RFI'S FOR "D" WARE HOUSE

Subject: **Report of Geotechnical Services**
AKA D. Ware House Stormwater Pond
1167 Kingsley Avenue
Orange Park, Florida
Wood Project No. 6734-19-9981

SHEET
C-2

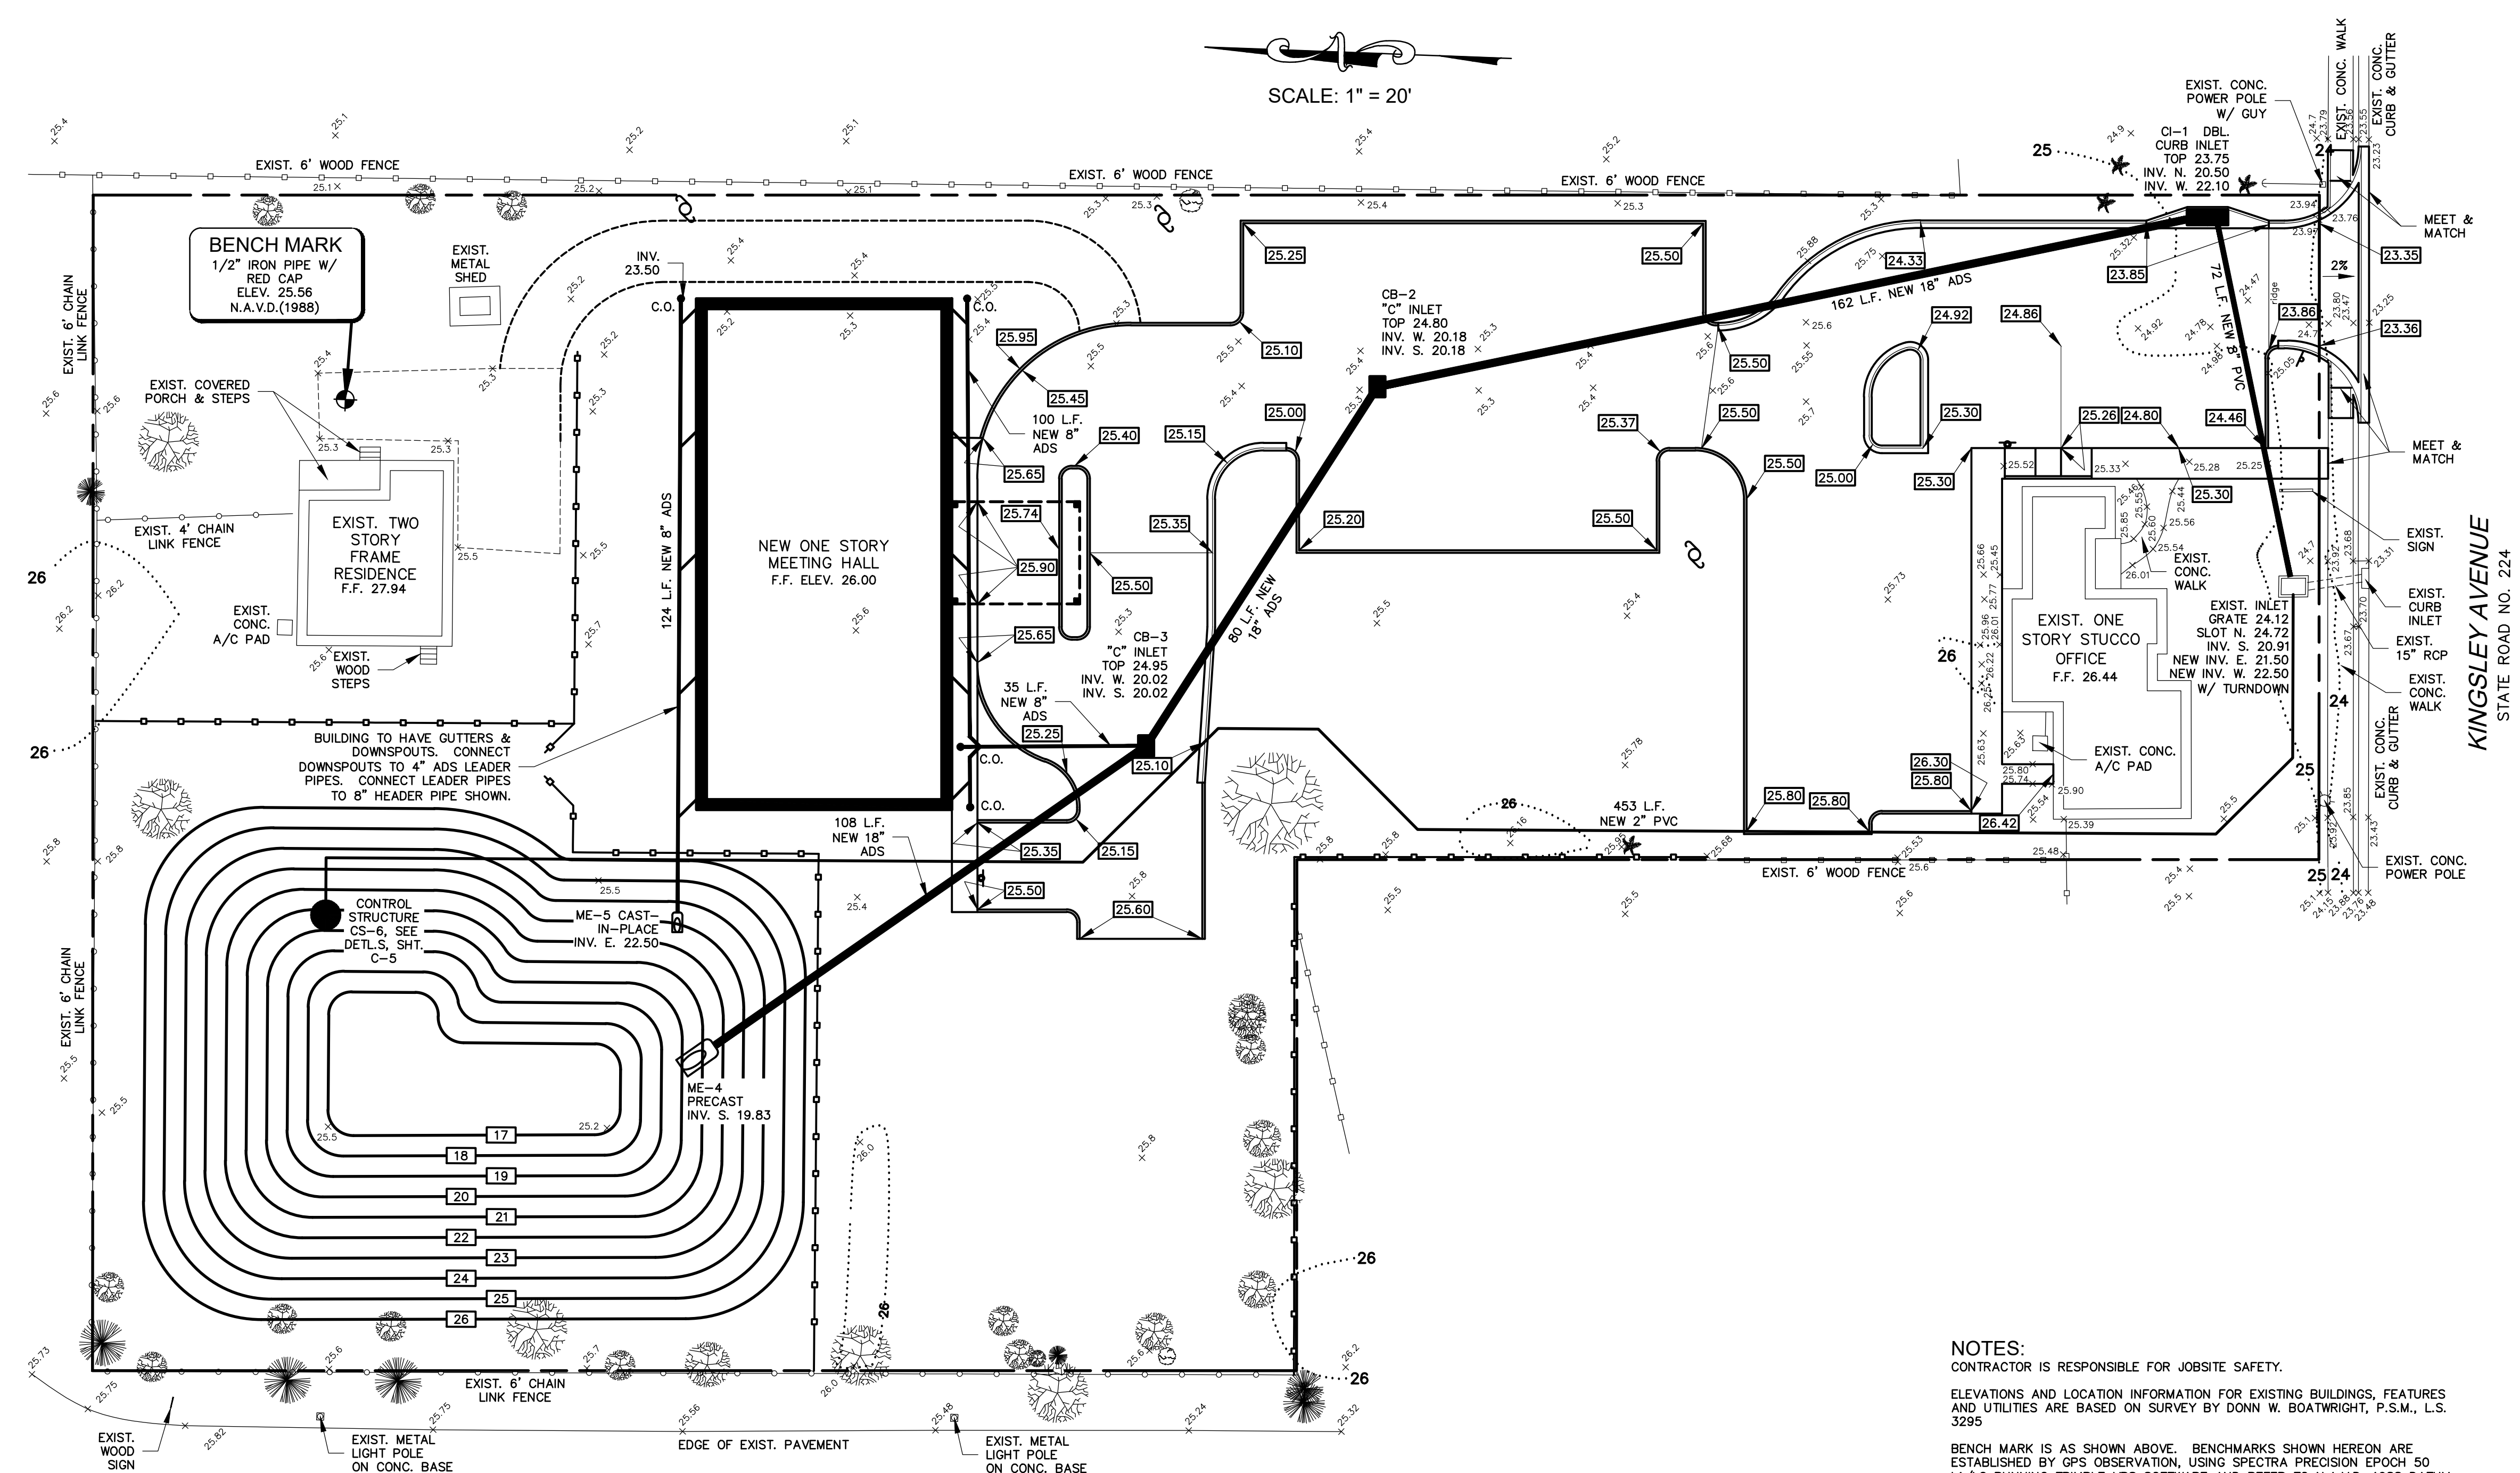
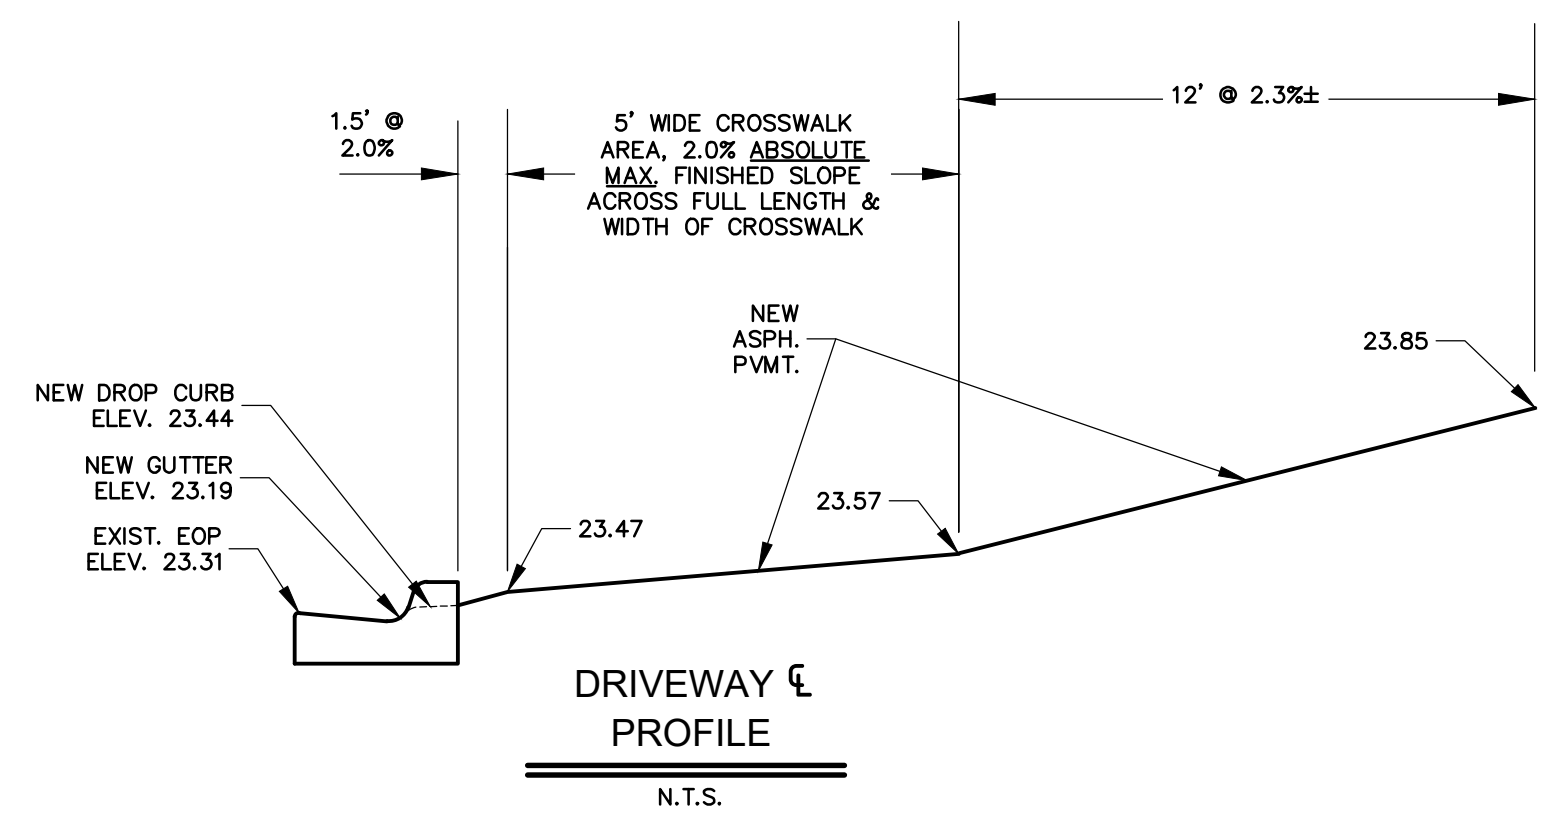
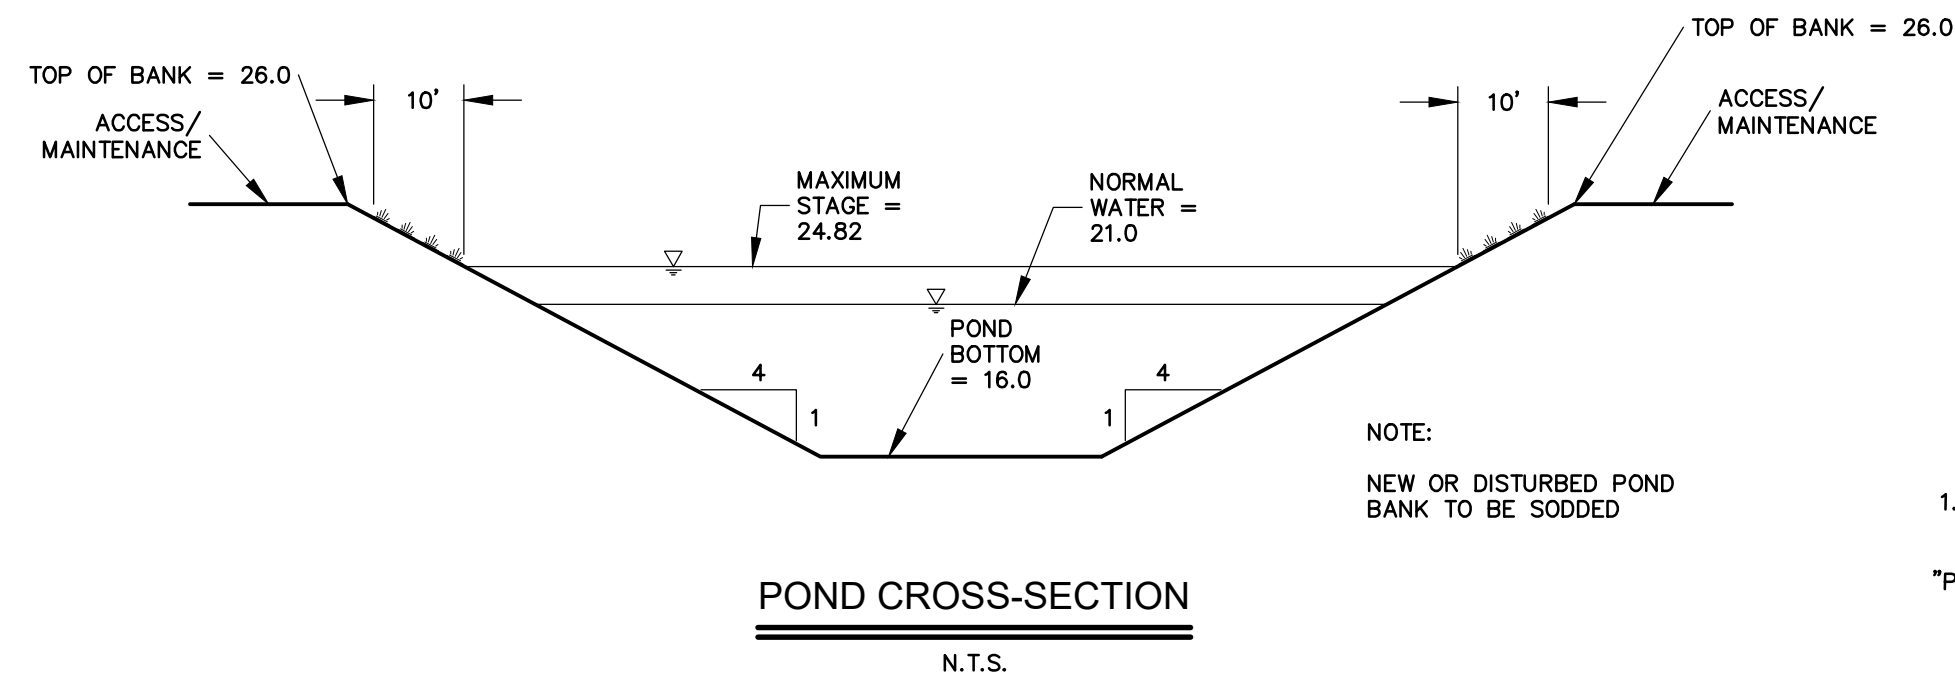
21. *Drawing C-2 shows connecting the downspouts on the back (north) side of the building to storm drain. However, the downspouts on the front (south) side of the building have no storm drain provisions. Please verify this was the design intent.*

My early design concerns always center around where it's going, but less on how it's getting there. However, it is critically important to keep Brian happy. ;) So, please see attached revised sht. C-2 showing collection piping for south side. Plan from Brian's version of # & location of downspouts, not mine.

SHEET C-5

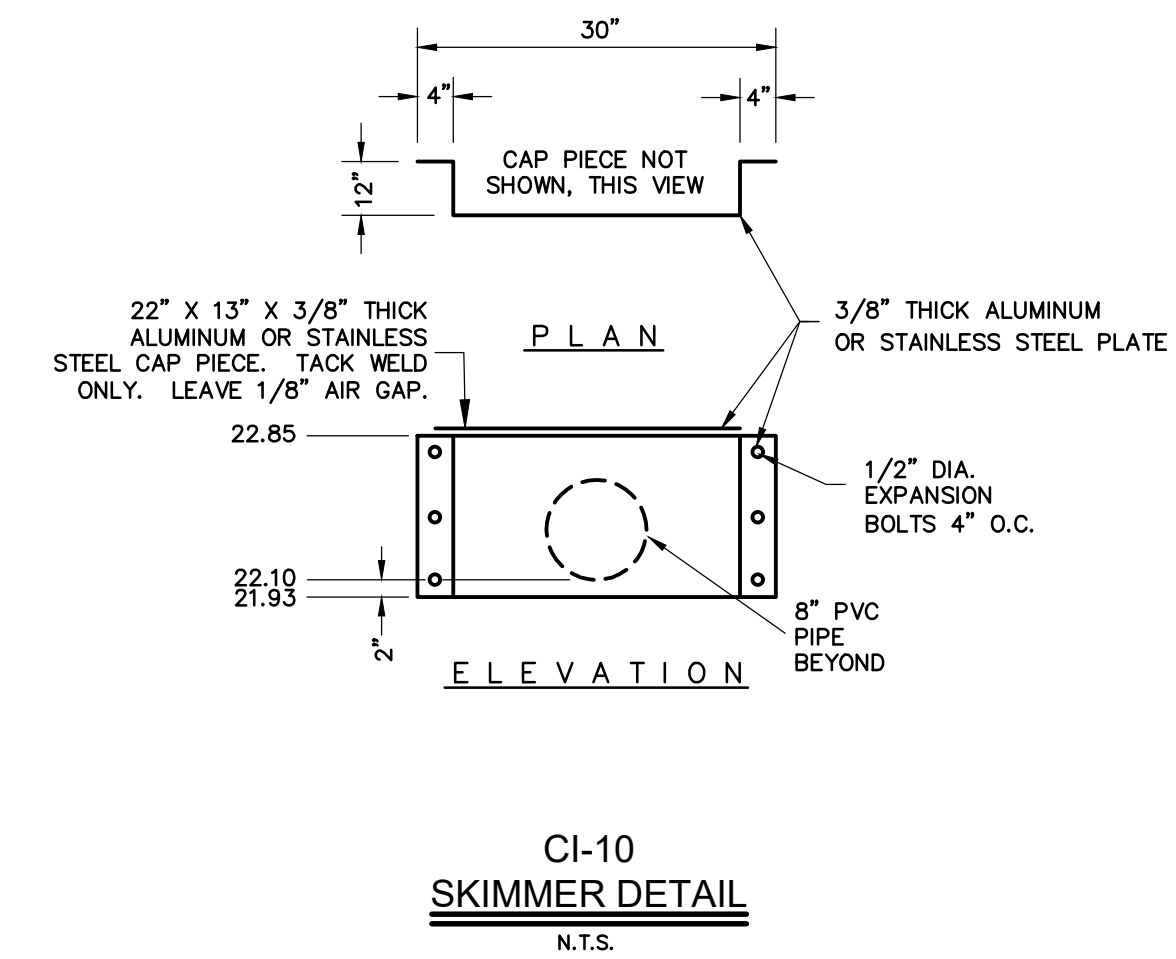
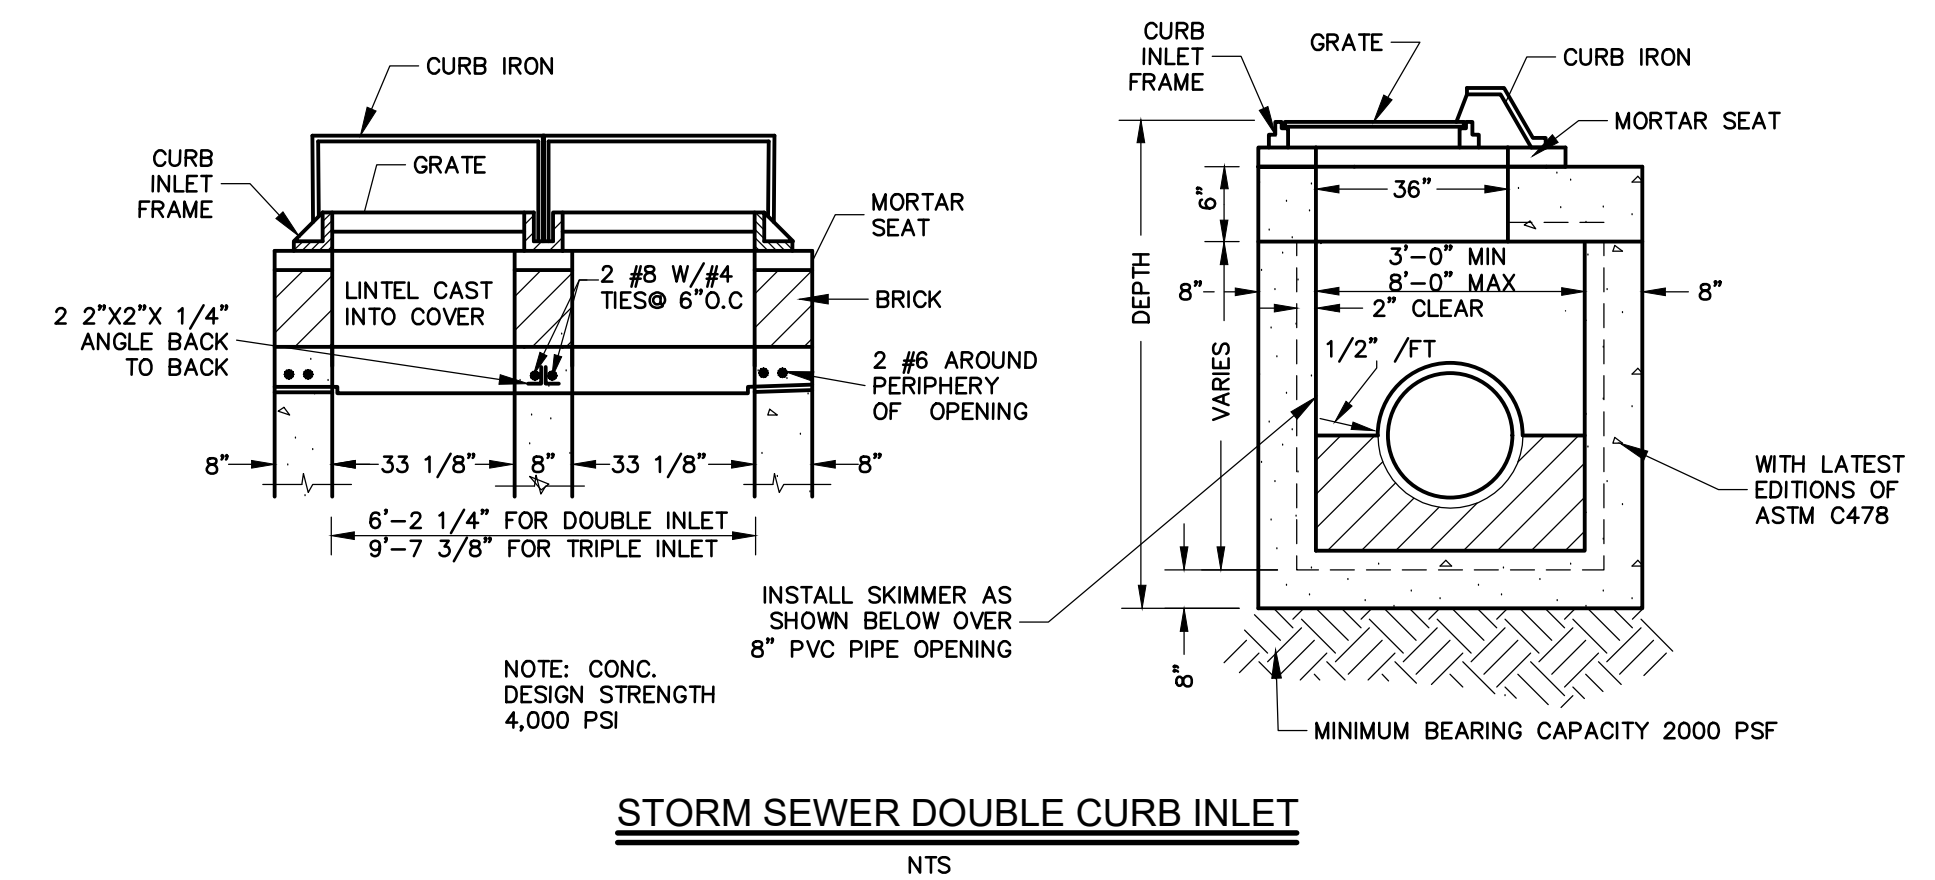
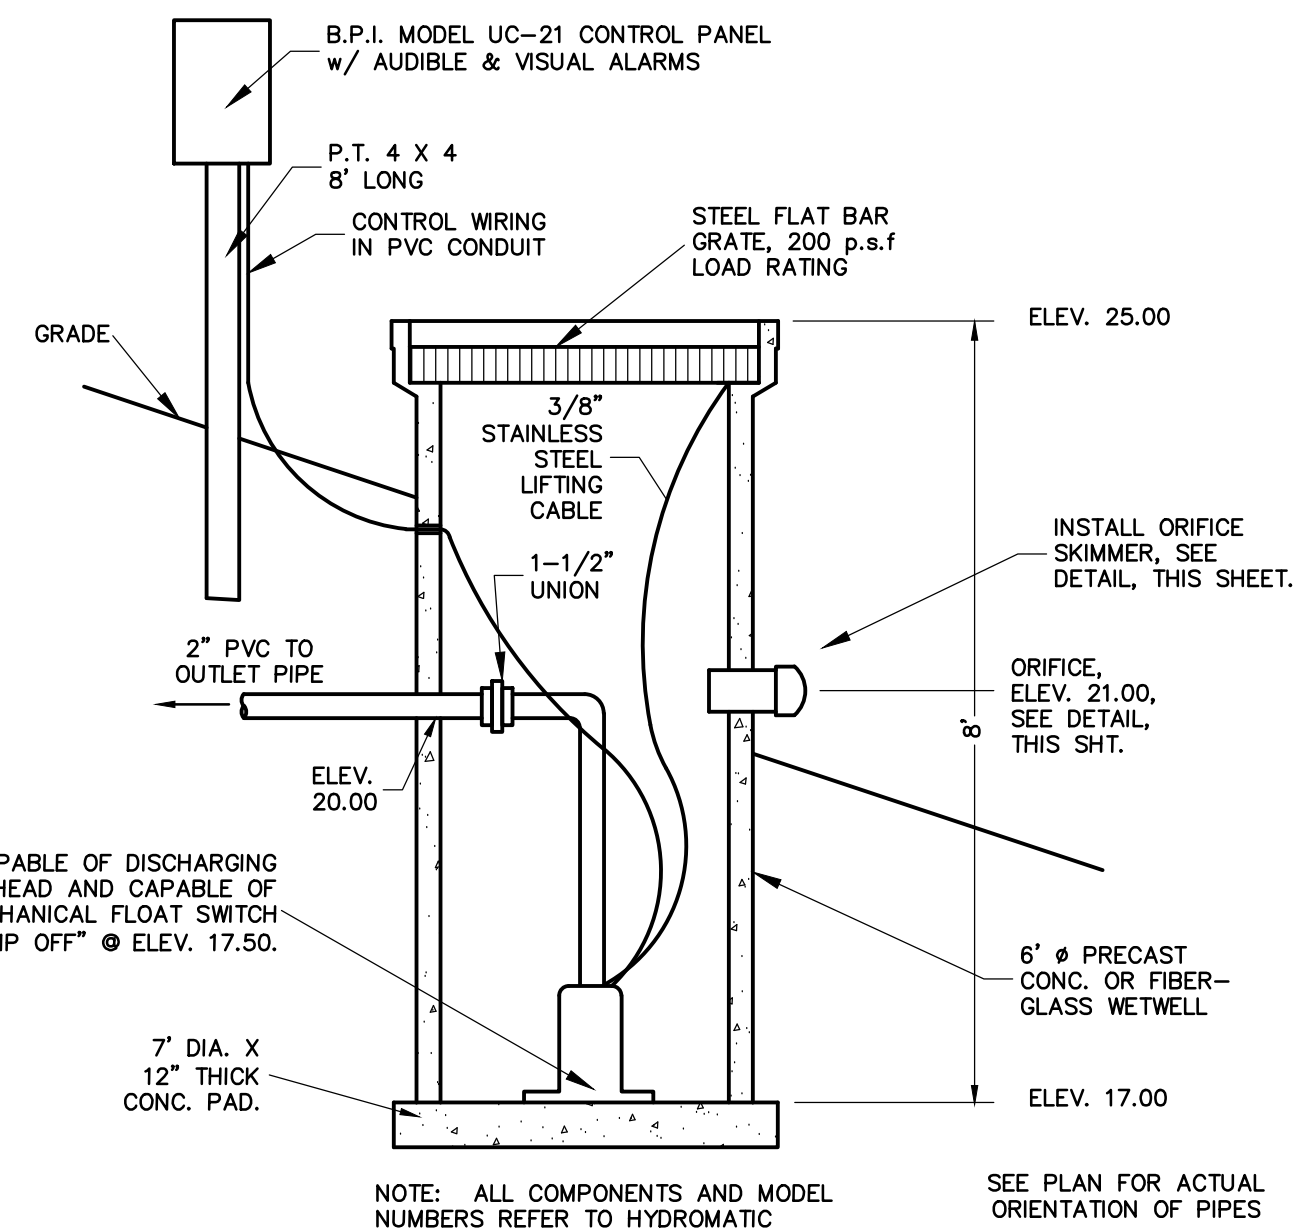
Also, don't know which version you are pricing, but the pump size was in error on sht. C-5 on an early version. Please see the attached. Note that this may affect your electrical as well.

1.0 H.P. HYDROMATIC PUMP, CAPABLE OF DISCHARGING 110 GPM AT 4.8 FT. OF HEAD AND CAPABLE OF CONTINUOUS OPERATION. MECHANICAL FLOAT SWITCH "PUMP ON" @ ELEV. 20.50, "PUMP OFF" @ ELEV. 17.50.
